Kaizer Knitwears Ltd.

21st May, 2018

Observations

Column and Shear wall layout plan

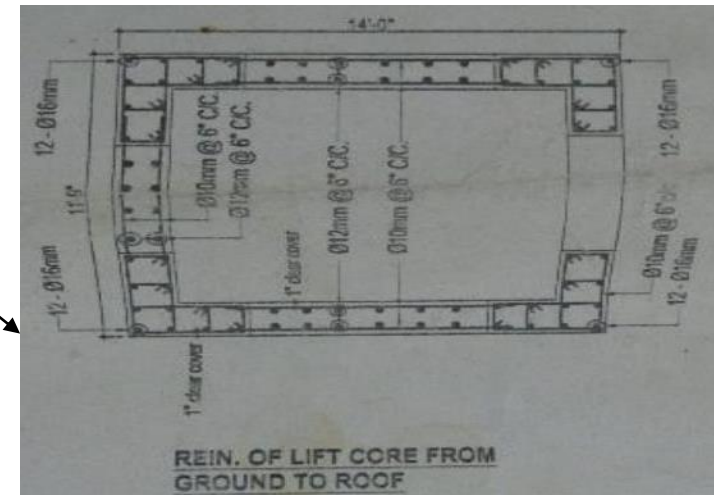
Lateral stability system to be verified

As per drawing, there are two shear walls provided for the structural system which was not constructed on site. Actual design may have considered the shear walls to resist lateral loads. Building engineer is required to check the structural system considering the moment resisting frame actions.

Floor layout plan not matched with site condition.

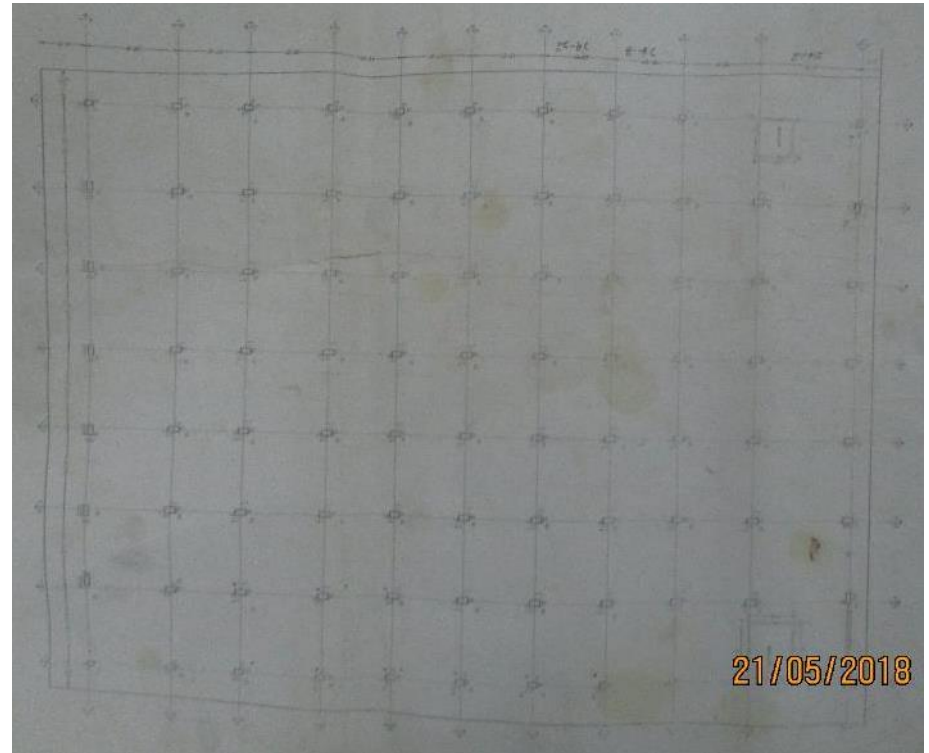
As built drawings not indicative to the site condition

6 bays constructed instead of 7 in East-West direction. Also stair position not matched.

No credible as built drawings were available on site for review. Building engineer is required to survey the structure and prepare accurate as built drawings.
